PLANNING COMMISSION MEETING

August 31, 2023
4:00 PM

To: Plan Commission

Halron Brothers, LLP.
Site Plan & Architectural Review
611 25th Avenue North
August 25, 2023

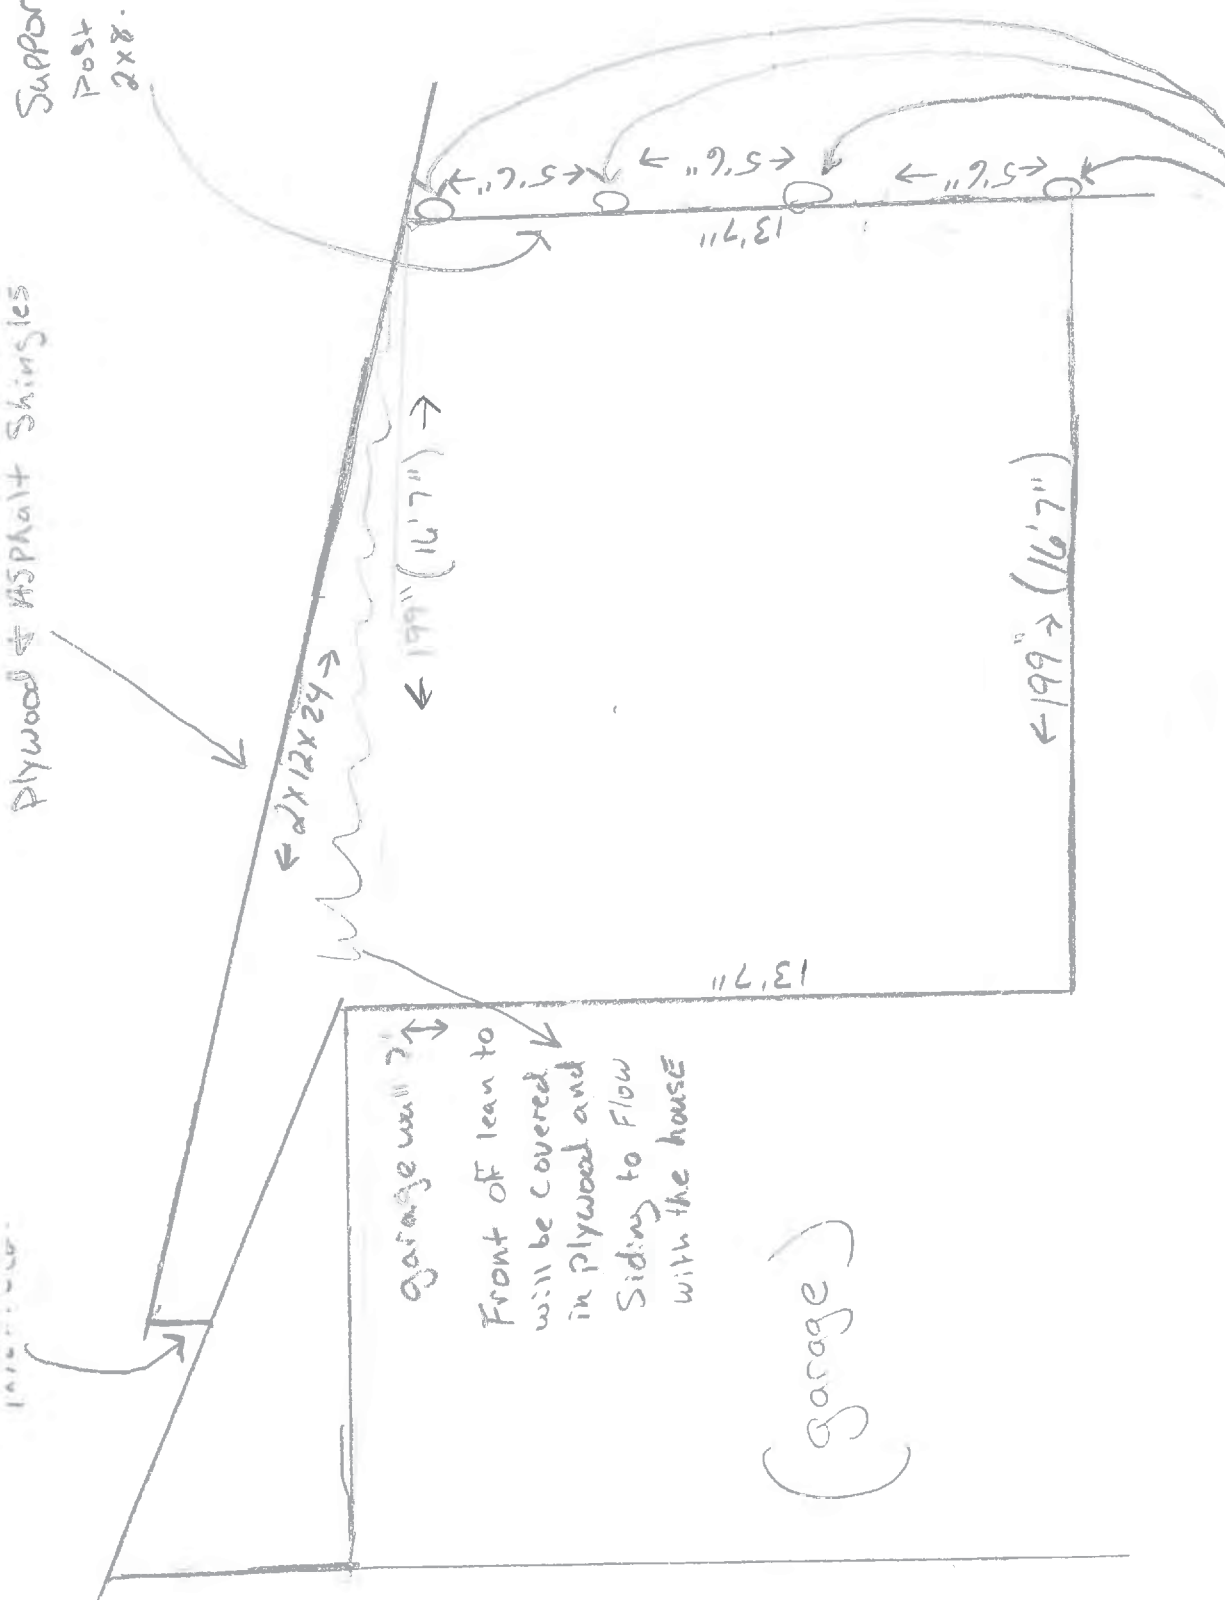
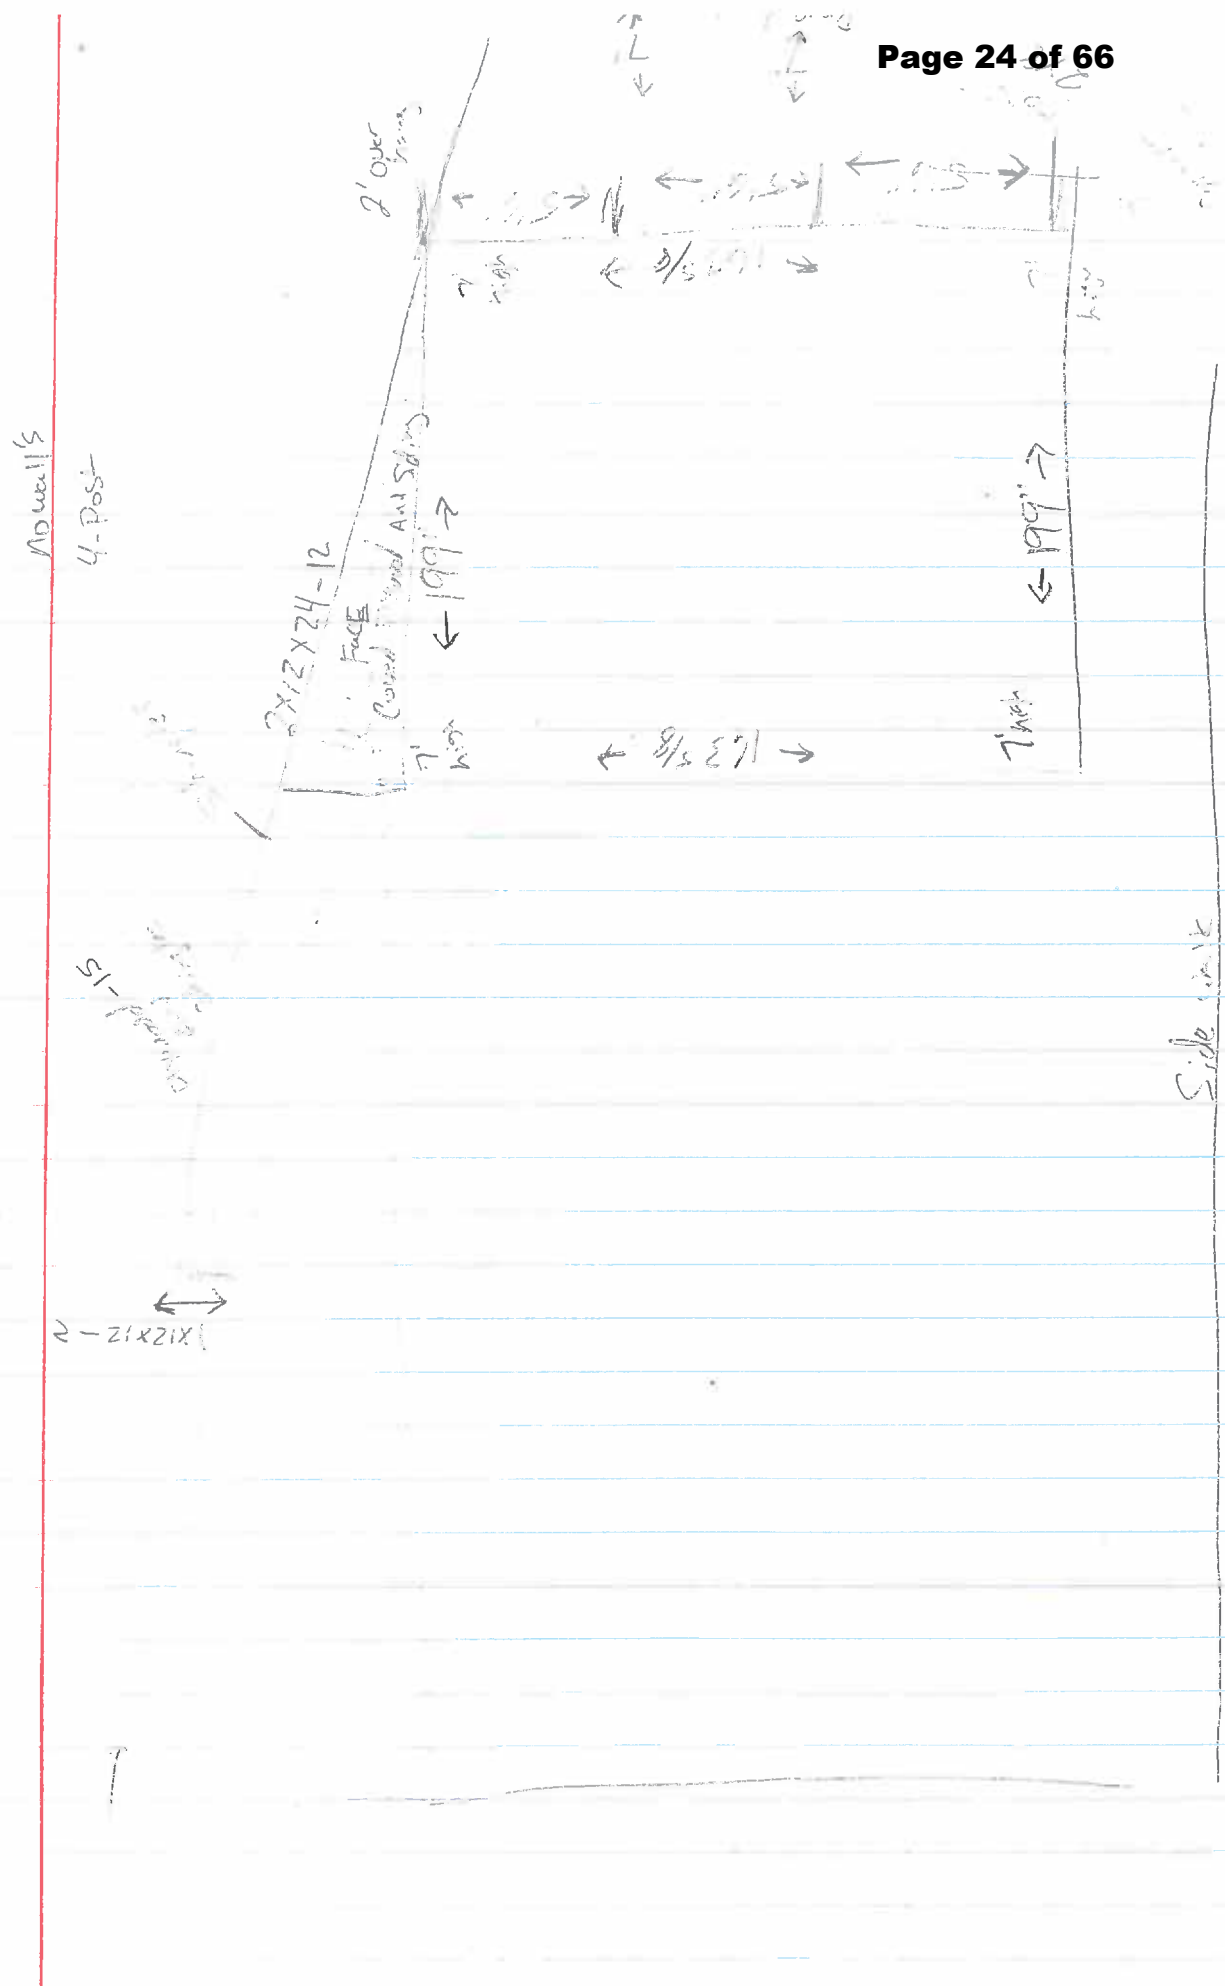
Arguably in this case the garage does not dominate the front façade of the single-family residence. In addition, the additional attached garage space is over by only marginal amount as up to a total of 578 square feet of attached garage space is permitted and a total of 766 square feet is proposed. Overall, the addition is 188 square feet over the maximum allowed. Conditions have been added requiring that the 188 square foot in overage be deducted from the allowable square footage of any future detached accessory buildings, in line with the ordinance.

The net effect is largely neutral. The 238 square foot covered storage area would be keeping in scale with the existing home and garage. The Plan Commission has the ability to review and approve the proposal subject to the special exception process.

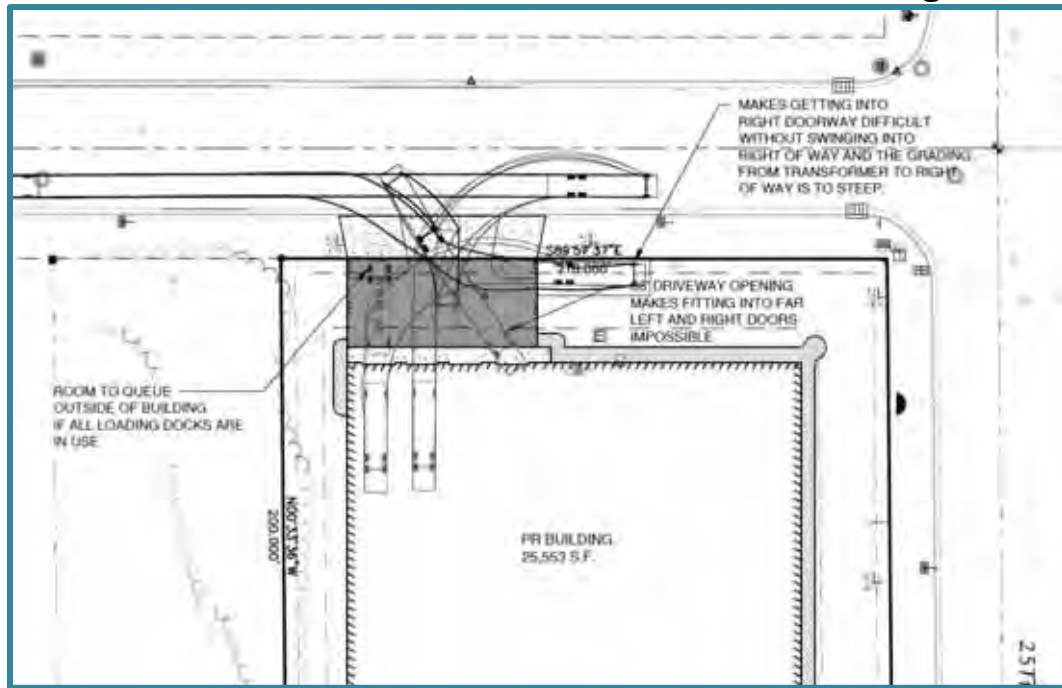
The existing building is 28,212 square feet and the proposed expansion will add an additional 25,553 square feet. Other proposed site improvements include three overhead bay doors along the northern building elevation for tanker truck loading.

(11) Overhead doors shall not face a public street. The Planning Commission may permit overhead doors to face a public street, but only when it has made a finding that there is no feasible alternative location for such doors. Consistent with the requirements in Article 5, the Planning Commission may approve a special exception to allow an overhead door to face a public street when there is no feasible alternative.

Staff would recommend approving a Special Exception to permit the overhead doors to face a public street, as tanker trucks would need access from a public street, and the building configuration as proposed is appropriately suited to the industrial park. A paved area and apron are proposed to the north to provide vehicle access to the bay doors, which the vehicles will access by backing into the building. The remaining area surrounding the addition will be graded and landscaped.

Analysis: The 25,553 square foot proposed building addition meets setbacks, will create 52 percent building coverage on the lot, and 81 percent impervious surface coverage on the lot. The building height is approximately 29 feet with an additional exposed four feet below the finished ground floor, for a total of 33 feet.

- I. All building exteriors facing a street or approved way shall have 50 percent of the street face constructed with brick, decorative masonry, glass panel, or other appropriate similar finished façade. Such brick, masonry, glass, or other decorative facing shall extend for a distance of at least 25 feet along the sides of the structure or at least 25 percent of the that side wall distance, whichever is greater.
- II. Principal buildings with a front elevation of more than 750 square feet in area shall be divided into distinct planes of 500 square feet or less.
